ARIZONA DEPARTMENT OF ENVIRONMENTAL QUALITY

November 30, 2017
FPU18-105

RE: WAFB – ADEQ comments - *Draft, Soil Vapor Extraction System/Steam Enhanced Extraction System, Operation and Maintenance, 2016 Third Quarter Performance Report, Former Liquid Fuels Storage Area, Site ST012, Former Williams Air Force Base, Mesa, Arizona*; prepared for Air Force Civil Engineer Center (AFCEC/CIBW), Lackland AFB, TX; prepared by Amec Foster Wheeler Environment & Infrastructure, Inc. (Amec), Phoenix, AZ; document dated October 20, 2017.

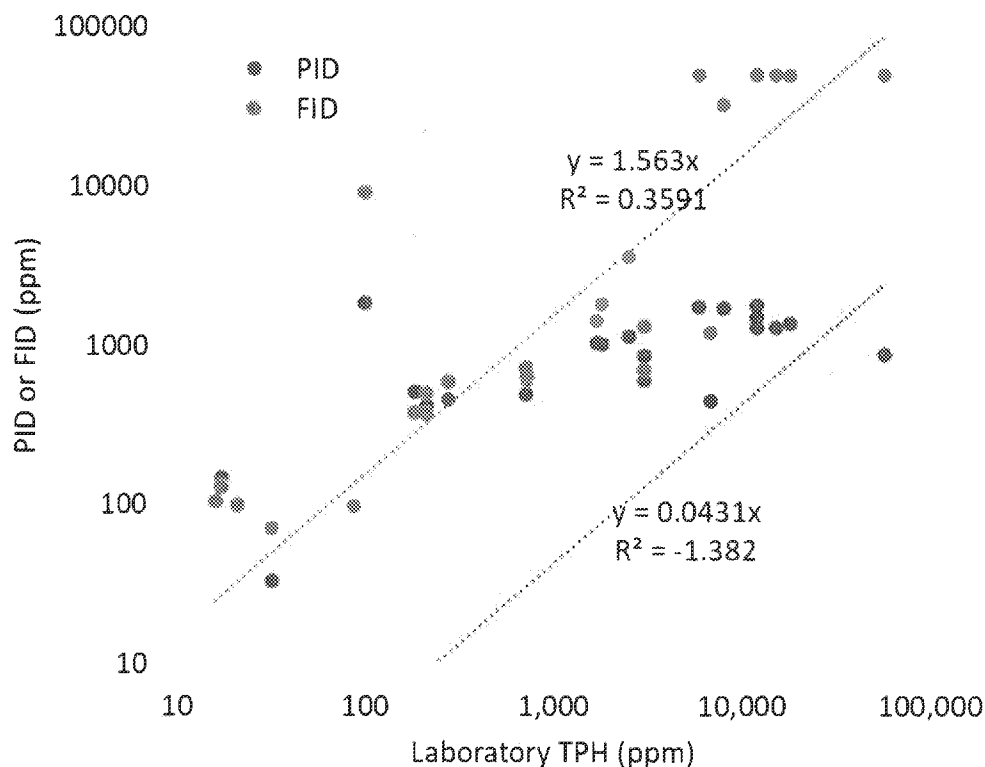
GC 6: Soil vapor extraction (SVE) optimization discussion should be expanded. Optimization should consider:

- 6a) Mass removal rate from individual wells
- 6b) Location of extraction well with respect to contaminated soil volumes.
- 6c) Location of contaminated soil volumes with respect to well screen interval
- 6d) Potential to promote dormant or low mass producing wells into vent wells to increase flow through contaminated zones and minimize stagnation zones
- 6e) Thermal and flame oxidizer operating parameters to maximize the total mass extraction rate while focusing the subsurface flow through the most contaminated soil volumes

14. Page 2-21, Section 2.4, Line 800.

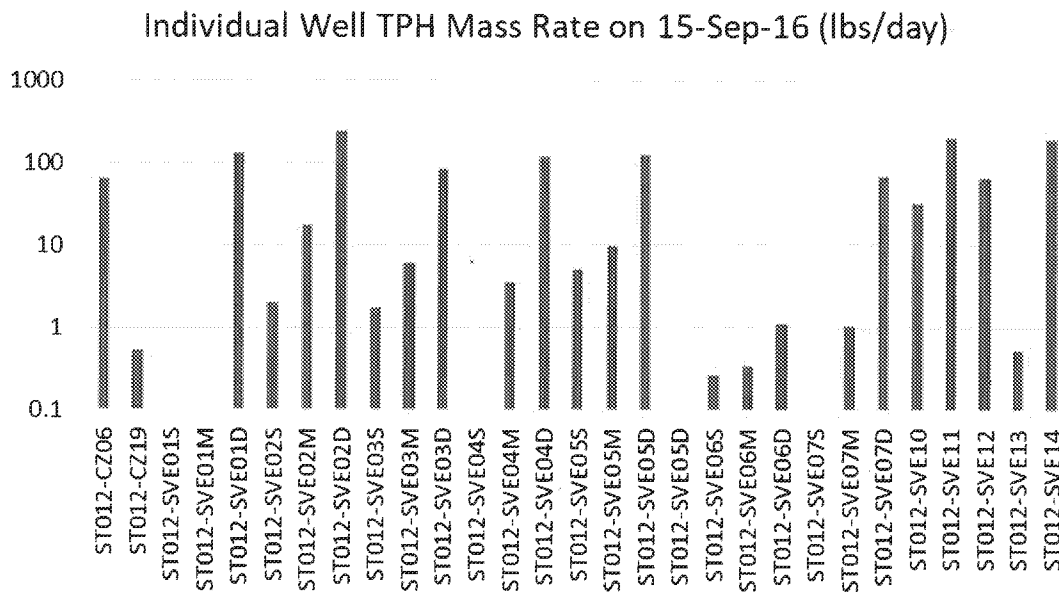
The following figure presents plotted data points. Neither the PID nor the FID data display correlation with the TPH laboratory data. A similar lack of correlation exists between the PID data and a sum of the BTEX data. Hence, only the laboratory data should be used for mass removed calculation. No remedial performance evaluation or decision regarding a remedial approach change should be based on PID or FID field readings.

- a. Please discuss optimization of the SVE system in relation to the following discussion, and consideration of the screen interval and location of each well. Line 800 states “Continue to operate the system and evaluate optimization based on individual well vapor concentrations.” The laboratory data and individual well flow measurements for Sept. 15, 2016 (listed in the table with Comment 9) were combined using the equation in Appendix A to calculate the mass removal rate of hydrocarbons on that date. The results are plotted below. Wells producing low mass rates may be creating stagnation zones within more contaminated soil volumes between wells. The highest individual extraction rate is found in well CZ19 but little hydrocarbon mass is produced. Please discuss the potential to turn dormant or low mass producing wells into vent wells to increase flow through the more contaminated soil volumes to optimize operations.

- b. Please add a statement and discussion regarding optimization based on the design parameters of the thermal oxidizer and the flame oxidizer. For example, the flame oxidizer should not require any dilution for the reported site conditions such that low mass producing wells could be shut off to increase flow from more productive wells and reduce the number of stagnation zones between wells; however, the thermal oxidizer would then likely require more dilution air. Maximizing the total mass removal rate for the two oxidizers and focusing the subsurface flow through the most contaminated soil volumes is a worthwhile optimization procedure.
